from
**Southern
Water**

Your ref
BN/42/21/PL

Proposal: Demolition of existing dwelling, garage & commercial buildings & erection of replacement dwelling, garage & commercial building (Use Class B1 (E) B8) with associated vehicular accesses from Eastergate Lane & hard and soft landscaping. This site is in CIL Zone HSP2 (Zero Rated) & is a Departure from the Development Plan.

Site: BN/42/21/PL: - Folly Foot Farm, Fontwell Avenue, Eastergate, PO20 3RU.

Southern Water MapGuide Browser

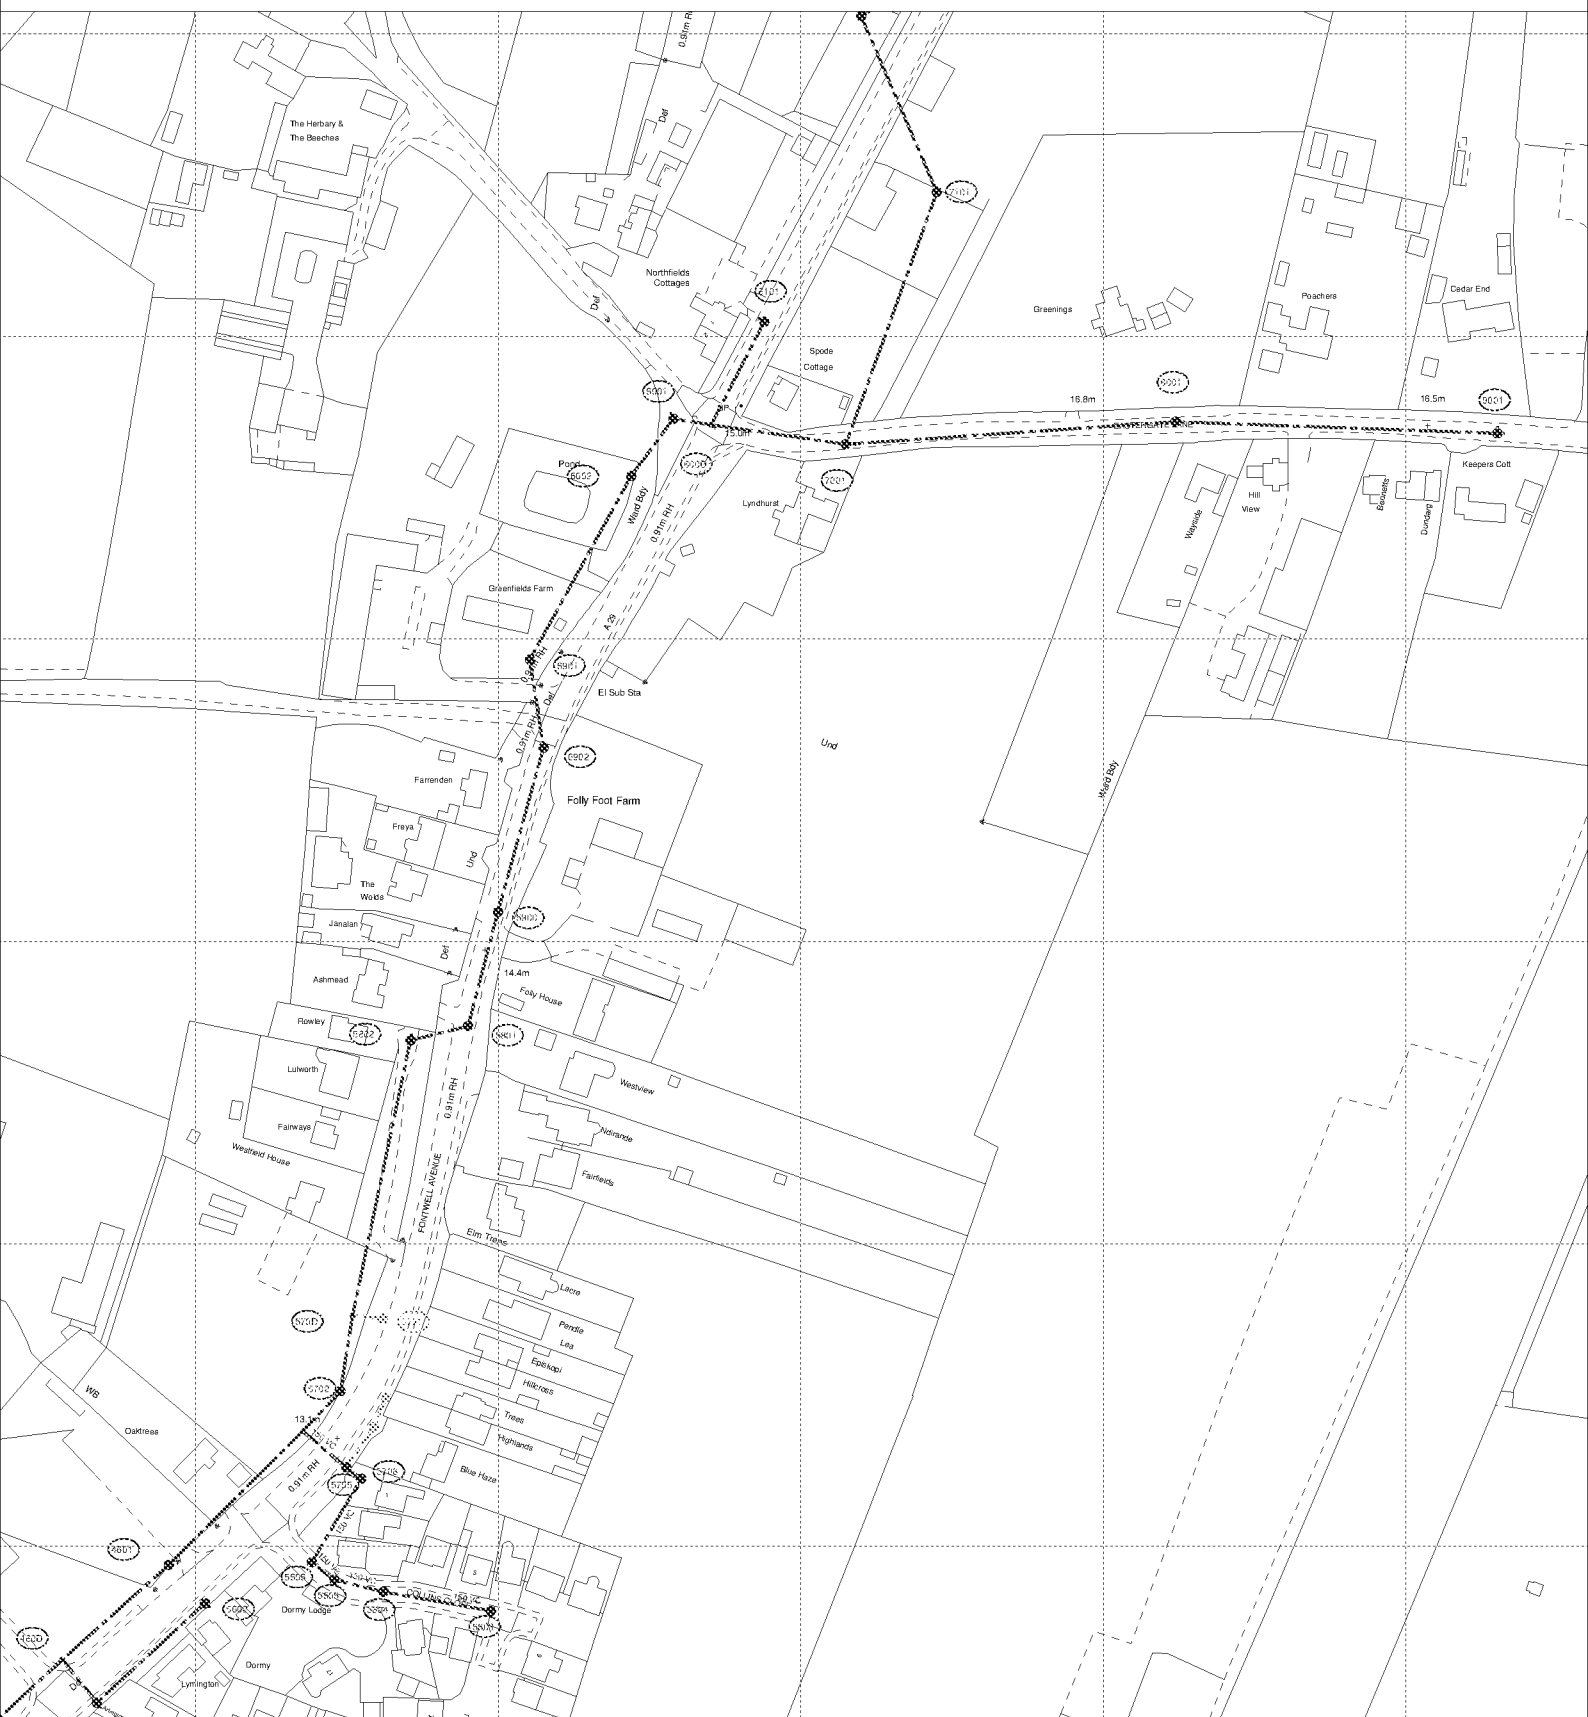
It is possible that a sewer now deemed to be public could be crossing the development site. Therefore, should any sewer be found during construction works, an investigation of the sewer will be required to ascertain its ownership before any further works commence on site.
